Access Compliance Report

Public Rights-of-Way

(Curb Ramps)

Intersection ID: 6014	Main Street: RUMPLE_RD	Cross Street: RIDGE_LANE_RD	Location: NE
ADA ID: A67BDD75ADBC	Ramp Type: PerpDiag	Initial Pass/Fail: Fail	Overall Compliance: No
		Severity Score: 12.5

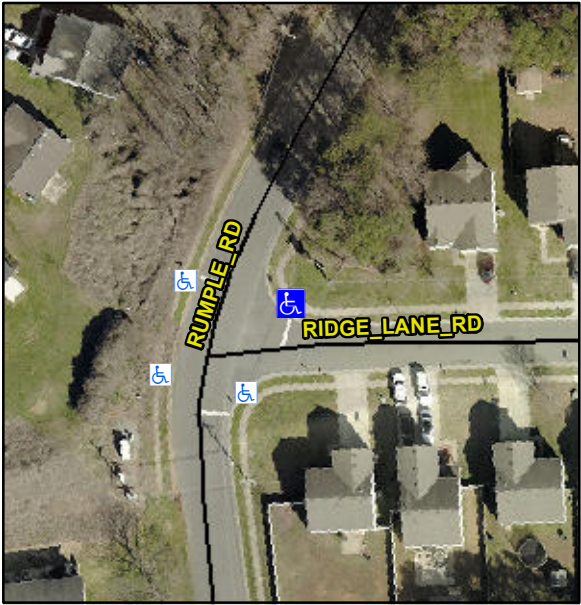
Codes/Mitigation Info/Possible Solution			Field Measurements/Component Compliance		
	Possible Solutions:		Compliance	Description	Data
	Remove & Replace Curb Ramp With Two New Directional Ramps or Equivalent.		Yes	Ramp Length (in)	49.0
			N/A	Ramp Width (in)	48.0
			N/A	Flare Type LT	N/A
			N/A	Flare Slope LT (%)	N/A
			N/A	Flare Traversable LT?	N/A
			N/A	Landing Length (in)	N/A
			N/A	Landing Width (in)	N/A
			N/A	Landing Slope (%)	N/A
			N/A	Landing X Slope (%)	N/A
			N/A	Landing Curb? (Y/N)	N/A
			N/A	Shared Landing?	N/A
			N/A	Gutter Ponding?	N/A
			N/A	Gutter Lip Ht (in)	N/A
			N/A	Painted X Walk1?	No
			N/A	X Walk 1 Direction	To W
			N/A	X Walk 1 Width (in)	N/A
			N/A	X Walk 1 Slope (%)	2.9
			N/A	X Walk 1 X Slope (%)	5.5
			N/A	Ramp inside XWalk1?	N/A
<p>Surveyor Notes:</p> <p>N/A</p> <p>PROW/ADA:</p> <p>R304.5.3</p>			N/A	Flare Type RT	N/A
			N/A	Flare Slope RT (%)	N/A
			N/A	Flare Traversable RT?	N/A
			N/A	DWS Provided?	N/A

N/A	DWS Contrast?	N/A
			N/A	DWS Length (in)	N/A
			N/A	DWS Full Width?	N/A
			N/A	DWS Offset (in)	N/A
			N/A	Gutter Slope (%)	N/A
			N/A	Gutter X Slope (%)	N/A
			N/A	Painted X Walk2?	No
			N/A	X Walk 2 Direction	To S
			N/A	X Walk 2 Width (in)	N/A
			N/A	X Walk 2 Slope (%)	4.4
			N/A	X Walk 2 X Slope (%)	2.8
			N/A	Ramp inside XWalk2?	N/A
			N/A	Clear Space?	N/A
			N/A	Clear Space to XWalk (in)	N/A
			N/A	Storm Grate/Utility Hazard?	N/A
			N/A	Storm Grate/Utility Type	N/A
			N/A	Surface Condition? (G/P)	Good
Total Cost:		\$ 3200.00
